Rezoning Transportation Analysis

Petition Number: #2022-044

Date	Description
08-19-2022	First Review (AO)
09-22-2022	Second Review (AO)

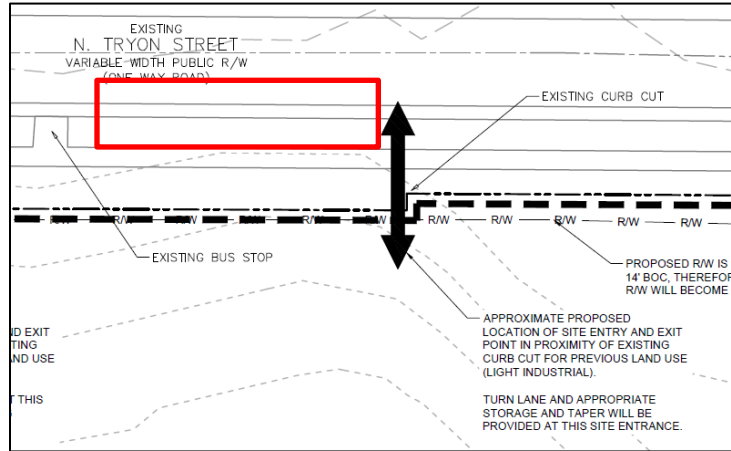
6. **Outstanding Comment from 8-19-22:** Revise site plan and conditional note(s) to commit to constructing a right turn lane with 100' of storage and appropriate taper on N Tryon St at proposed access points per NCDOT requirements.

Update to Comment (New Site Plan, 9-12-22): If a turn lane can't be provided at the site access it must be removed from the Rezoning Plan per NCDOT. It appears that further coordination with NCDOT is required. Include a layout of the proposed right turn lane on site plan.

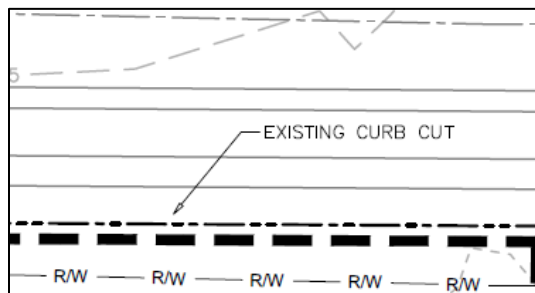
10. **New Comment (New Site Plan, 9-12-22):** Revise site plan removing existing driveway cuts only showing proposed access points for clarity. Note that existing curb cuts are to be removed
